**ADDENDUM NO. 2**

**Blossom Lake Park Improvements**

City of Seminole

January 18, 2022

**2 PARK BENCH SLAB DETAIL**  
SCALE: 1"=2'

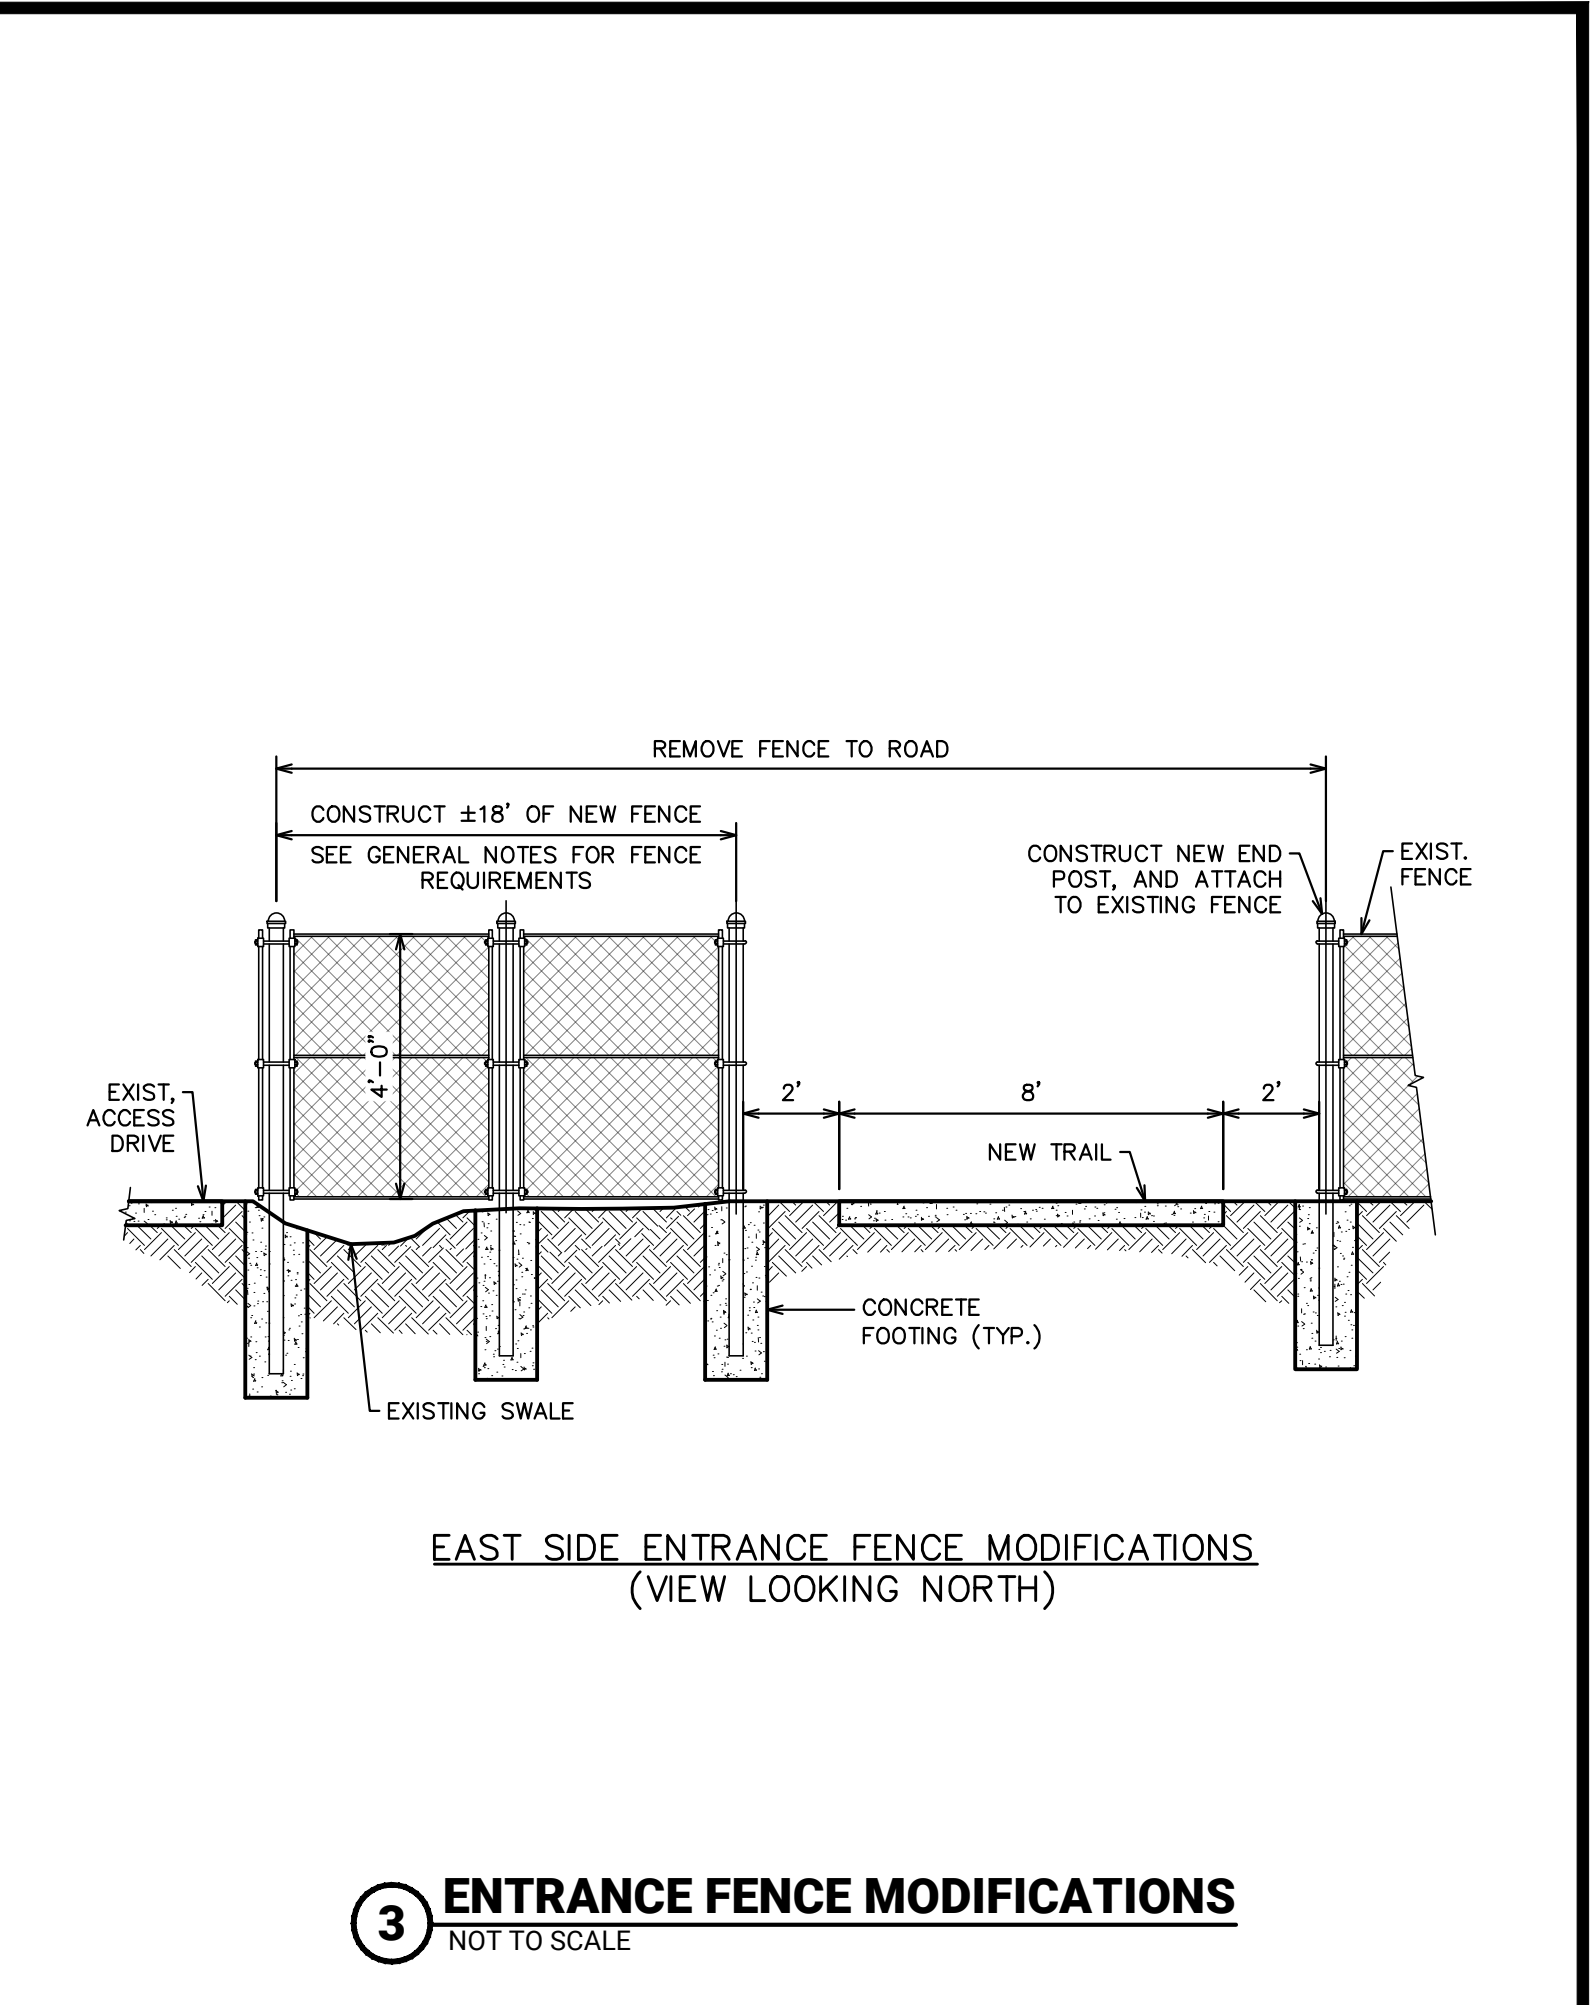
- a. Detail 2 – Park Bench Slab Detail
  - i. Slab thickness and reinforcement requirements have been revised.
- b. Detail 4 – Trail Typical Sections, Concrete Trail (Base Bid) / Concrete Trail with Tree Protection Measures
  - i. Expansion joint location requirement has been added to this typical section.
